## RESPONSE TO REQUEST FOR ADDITIONAL INFORMATION

### US-APWR Design Certification

**RAI NO.:** NO. 960-6709 REVISION 4  
**SRP SECTION:** 03.07.02 – Seismic System Analysis  
**APPLICATION SECTION:** 3.7.2  
**DATE OF RAI ISSUE:** 09/24/2012

#### QUESTION NO. 03.07.02-216:

Figure 1. Displacement difference between decoupled and coupled analysis versus  $T_s/T_m$ , for  $k_y = 0.2$  (modified after Figure 10c of Reference 7)

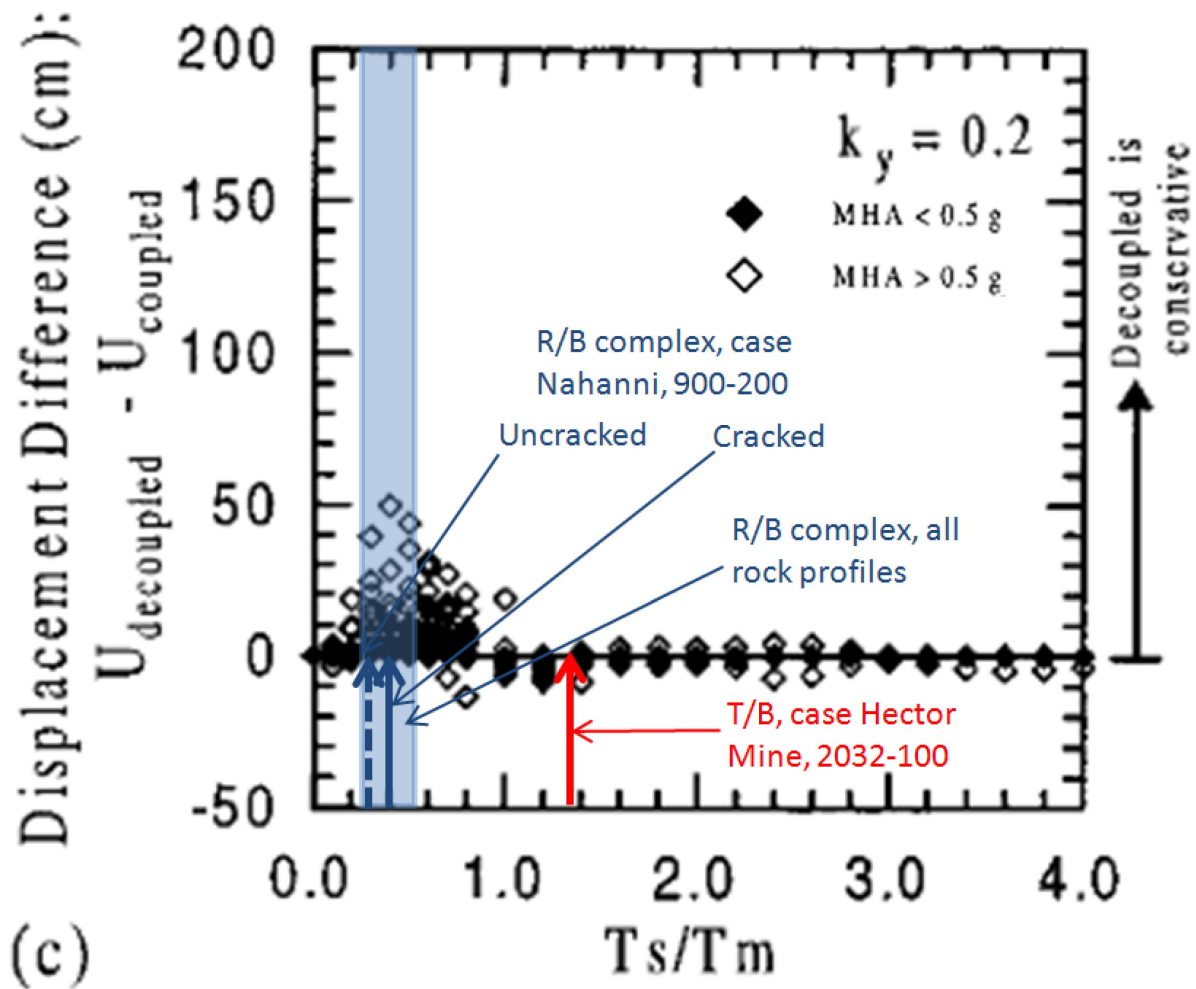
b) In Section 4.1, under Assumption number 2, the applicant indicated that it is assumed that a small amount of sliding will not modify the ground motion in the vicinity of the basemat. The applicant is requested to provide a quantitative measure of "small amount of sliding." The applicant also stated that, "this assumption is the accepted industry practice for such analyses." The applicant is requested to provide appropriate basis and references to demonstrate the industry practice for such analyses and that it has been accepted by the staff.

The parametric study results are presented in terms of these two parameters in Figures 10c and 12a of Reference 7, that are reproduced here as Figures 1 and 2, respectively. The markings in blue indicate results corresponding to the R/B complex with cracked and uncracked section, and the markings in red indicate results corresponding to the T/B.

Figure 1 shows the differences between coupled and decoupled analysis results obtained in the parameter study presented in Reference 7 as a function of the ratio between the dominant period of the structure and the dominant period of the seismic input motion. The markers relevant for US-APWR are the full markers, corresponding to maximum horizontal accelerations (MHA) smaller than 0.5g. For the parameters corresponding to the R/B complex (and indicated by blue arrows) all the results in the parameter study indicate that the decoupled analysis is conservative (i.e., the sliding calculated in a decoupled analysis,  $U_{\text{decoupled}}$ , is larger than the sliding calculated in a coupled analysis,  $U_{\text{coupled}}$ ). For the parameters corresponding to the T/B the difference between coupled and decoupled analysis results is about zero.

For the R/B complex, the parameters relevant to the study and used in Figures 1 and 2 (namely  $k_y/k_{max}$  and  $T_s/T_m$ ) have been calculated for all subgrade profiles and all input acceleration time histories. The ranges of these parameters for the rock profiles (900-200, 900-100 and 2032-100) that dominate sliding are indicated in Figures 1 and 2 by blue shaded areas, and are:

- Between 0.52 and 0.64 for  $k_y/k_{max}$
- Between 0.24 and 0.47 for  $T_s/T_m$

The comparisons presented in Figures 1 and 2 support the conclusion that, for the range of parameters used in the MHI sliding analyses, the decoupled method provides similar or slightly conservative results in terms of sliding as compared to the fully coupled method.
